Re: Daylight and Sunlight: 26/02109/FUL: Christs College Library, St Andrews Street, Cambridge CB2 3BU

Demolition of 1970s library and replacement with new library and social and study spaces and including re-provision of bridge to the Bodley Library.

Re: Daylight and Sunlight: 25/02161/FUL: Christs College Library, St Andrews Street, Cambridge CB2 3BU

Figure 1: Extract of Applicant's Shading Study Clearly Showing Additional Effects of Scheme

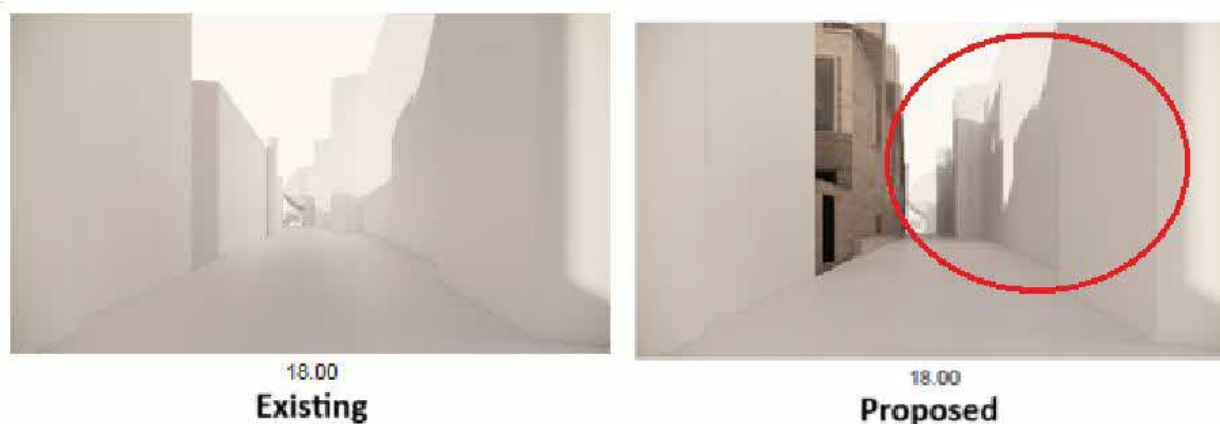
These changes are most clearly illustrated by the change in shading patterns extracted below showing darker shadows cast across the lane at 6pm on the summer solstice.

The assessments of shading on other dates within the architect's study appear inaccurate or difficult to judge. The image at 1800 on the equinox is presented in a pink blush and the images presented at 1800

on the winter solstice are effectively pitch black. Whilst this may represent a post sunset condition it clearly is not an 'accurate and objective' assessment as suggested by Turley.

The study presented does not accord with the BRE assessment criteria, shows only a limited angle of view, which appears to have been selected as favourable to the applicant and provides snapshots of selected dates including times where the shading effects are not legible.

It is clear that the proposal will have some shading effects which may affect the use of the lane which is not simply a transient passageway. A more comprehensive shading study would be required to fully understand the effects to the space. This should be produced by a specialist consultant and provide transient shadow paths comprising adequate dates, times and angles of view to fully enable an assessment of these potential impacts and to fully consider the concerns regarding the effect to the valuable public realm raised by the local community.

The latest additional documents, issued in September 2025, from Turley and Rights of Light consulting further seek to dismiss effects to the lane and state that 'it is not standard practice' to assess shading to streets. This is despite the concerns raised by local stakeholders Turley having previously engaged with these legitimate concerns in their letter and study of 18th July. Notwithstanding the deficiencies detailed above, that earlier study clearly showed change in the shading patterns within Christ's Lane (see figure 1).

The limits of the 2+hour study are illustrated in the applicant's conclusion that there is 'no effect' despite the applicant's own previous work showing the changes illustrated in figure 1 (above).

It is this shadow plotting, rather than the 2+ hour point in time study, that is required to fully assess the effects of the proposal. This should plot shadows across the areas of public realm and sitting out spaces at adequate dates, times and angles of view to fully enable an assessment of these potential impacts. Such
